Reviewer 2

The authors present an interesting and novel hardware/software package for computing river streamflow using camera imagery. In their package called the Computer Vision Stream Gauging (CVSG) system, they deploy a stereoscope camera paired with an edge computing device to capture stereo video in order to process into velocities, cross sectional geometry, and water surface plane determination. The CVSG is unique in that it does not require ground control points to perform image velocimetry analysis. Also, the CVSG uses a machine learning technique to improve results over time at a site as the equipment is allowed to collect more measurements. The CVSG seems to perform at least as well as other commercially available image-based velocity software. In one particular case, the CVSG completely outperforms other techniques, in part because it can interpret complex water surface profiles, such as cases with standing waves or other extreme conditions which normally highly degrade other common image velocimetry approaches. The authors do a good job evaluating the performance of the CVSG velocity and discharge results against standard/conventional methods and show excellent agreeme

Figure S1: Raw discharge measurements using different technologies along the length of the irrigation channel in NSW, Australia.

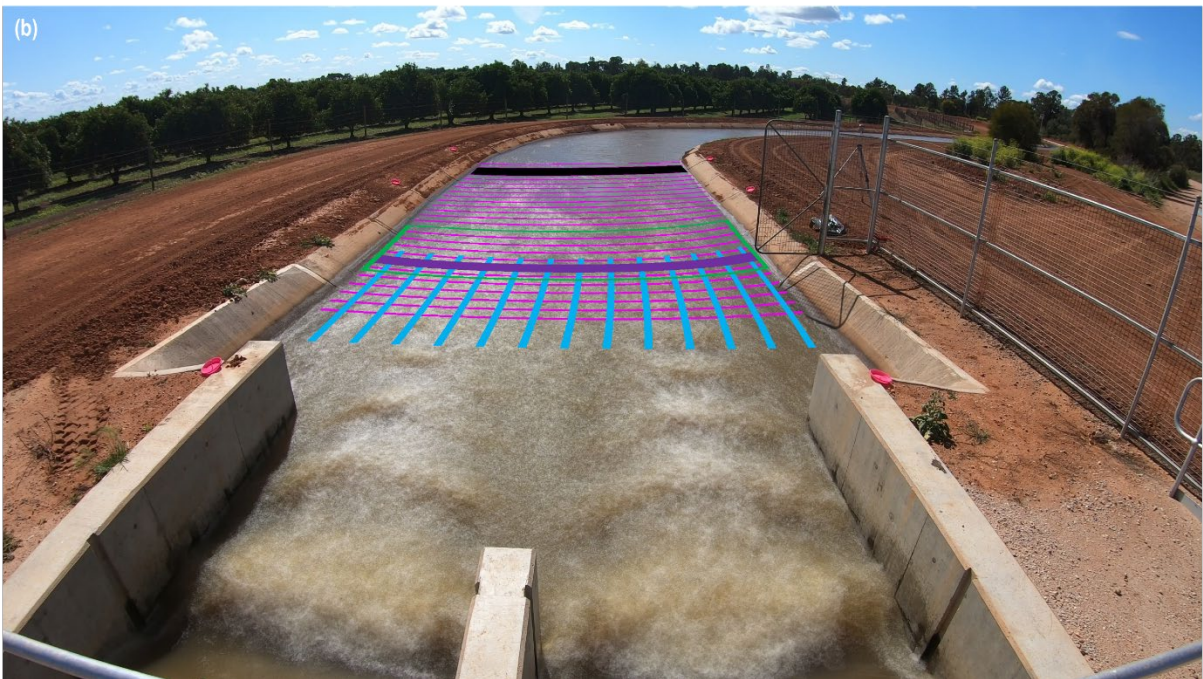
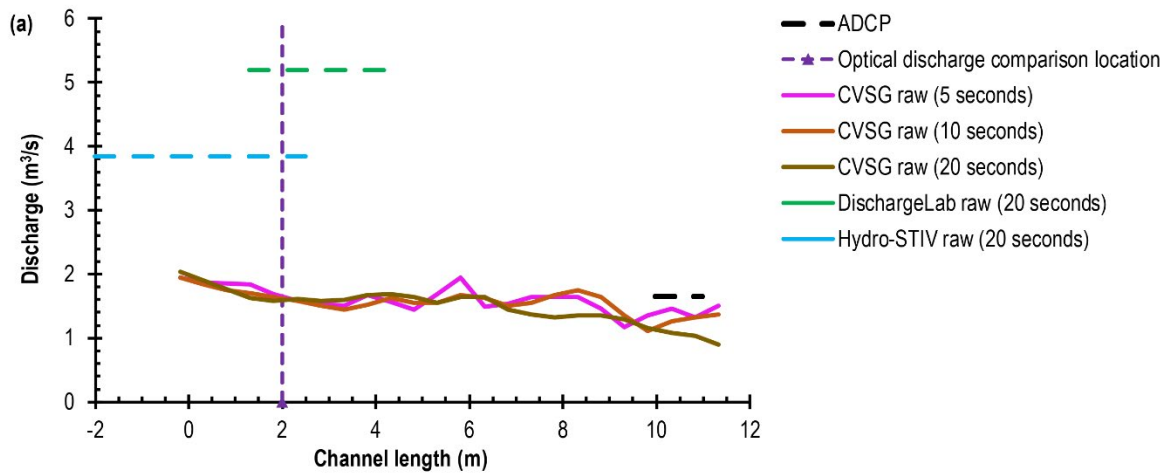
Figure 2: It would be helpful to annotate these images to include the region of interest used by each method for computation of discharge. For example, your results demonstrate that the CVSG dramatically outperforms other methods for the irrigation channel in NSW. I'd like to know where the STIV search lines were placed? What is the ROI for the SSIV processing?

Reply: The authors thank the reviewer for this feedback, and agree that this is a valuable illustration to provide to improve Figure S1 in the supplementary material with an annotated image. We have added this image as a second panel for Figure S1 (generated through programming a procedural pattern to apply to the coordinates for each region of interest).

Modification of Figure S1:

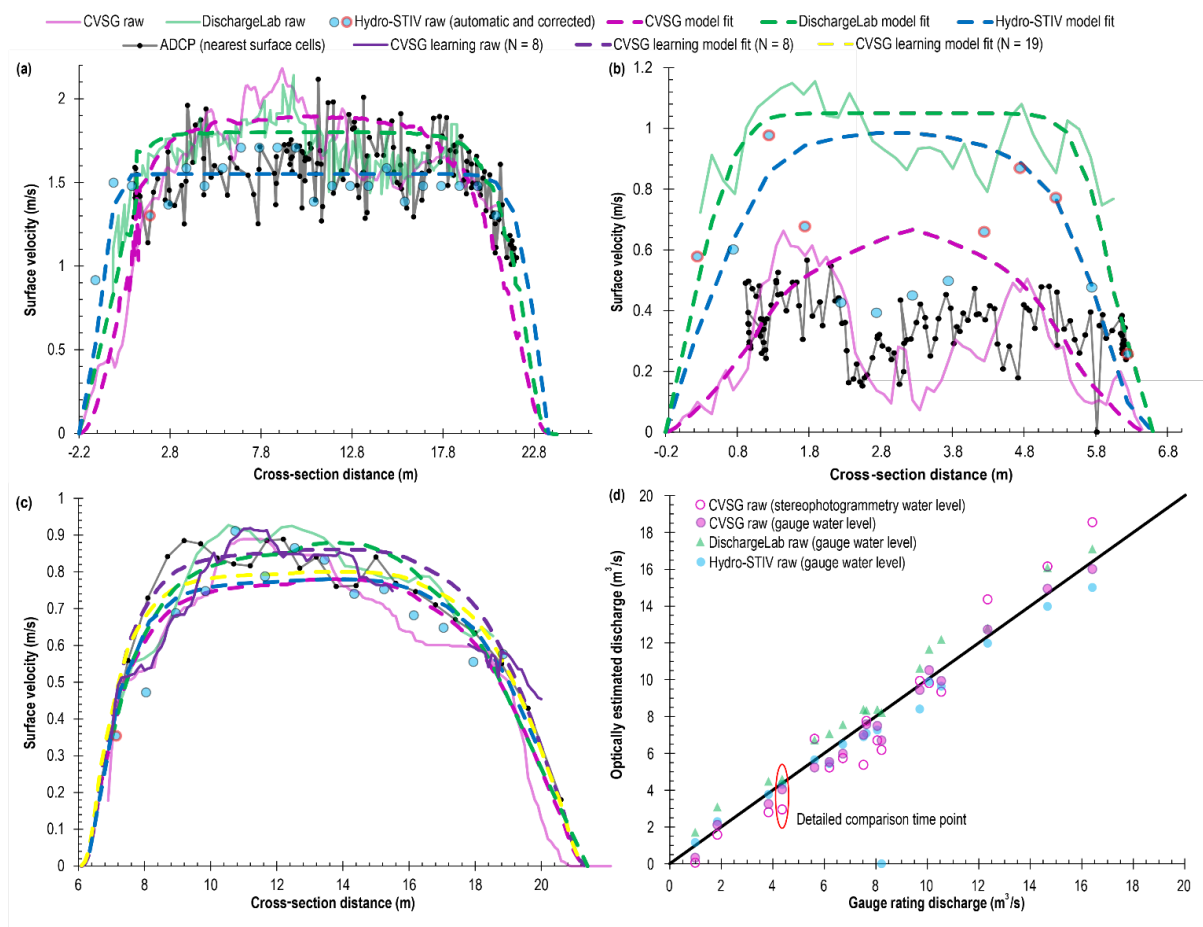
Figure 3:

It would be helpful to indicate that the ADCP data are the near-surface cell values. Additionally, label the plot to indicate these are surface velocity profiles. Although this is indicated in the text, it should also be included in the caption and/or figure legend.

Additionally, panel D may benefit from also including a residual plot. It seems that there is visually a trend in the CVSG results of under-predicting lower and over-predicting higher Qs. Alternatively, linear trend-lines could be added to show whether this is the case or not.

Reply: We thank the reviewer for these valuable suggestions for improving the manuscript. We have added the indication of the near-surface cell ADCP observations to both the figure legend and caption, as well as changing the y-axis for the surface velocity profiles to be labelled as such. The authors also thank the reviewer for their suggestion for Figure 3d, however the only significant trend present between lower and higher Qs is in the CVSG discharges applying the stereophotogrammetry estimated water levels, where this trend is already clearly observed and noted in the discharge rating of Figure 7 and L593-596.

Modification of Figure 3:
